RPB09-159 PRODUCT BULLETIN

TO: Residential Distributors
FROM: Jeff Gamache
DATE: 8/25/09
RE: GB5BM-0 R-410A Piston Change

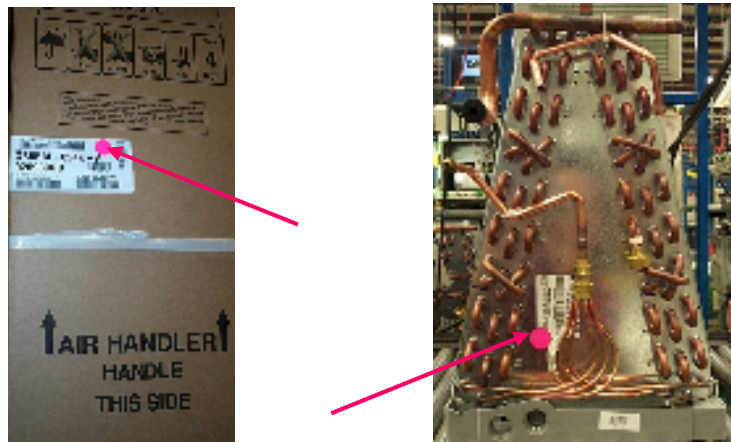
NORDYNE is pleased to announce a running change in the GB5BM-0 Piston Air Handlers. Beginning in late August Nordyne production is converting to the utilization of an R-410A Piston; current production models utilize an R22 piston. The change was driven to allow easier field matches to 13 SEER R-410A Heat Pumps. The only AHRI ratings that currently utilize a piston are 13 SEER R-410A Heat Pumps with Piston Air Handlers. The change can be noted on the rating plate label and we have added pink stickers to both the coil and carton labels to designate the R-410A piston change (Please see images below).
